TIFFIN

SB-55

120 Volt AC Load Balancing in Load Center on 2018 Allegro RED

Description: Correction of circuit breaker placement in 2018 Allegro Red

Figure 1. Correct circuit breaker layout.

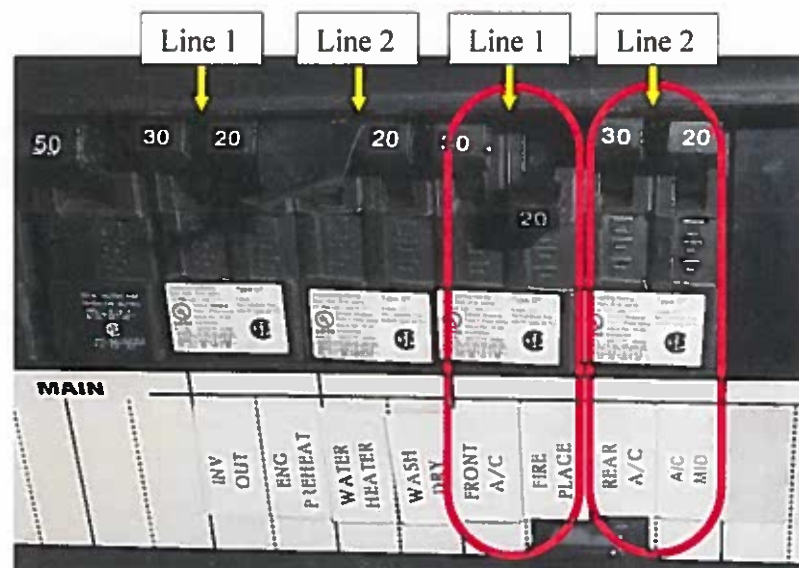
It has come to our attention that on some 2018 Allegro RED Motorhomes, there is the possibility that the wires connecting the air conditioners to the 120 volt AC load center were not properly installed. If this wiring is not corrected there could be some nuisance tripping of the generator circuit breakers.

4. Switch third and fourth circuit breaker to distribute air conditioner loads

- Remove the third and fourth circuit breaker and swap their positions so that they match **Figure 1**.
- Apply labels so they correspond to the loads and replace the plastic cover.
- Confirm that the FRONT A/C is now on line 1 and that the REAR A/C and A/C MID are now on line 2 as shown in **Figure 1**.
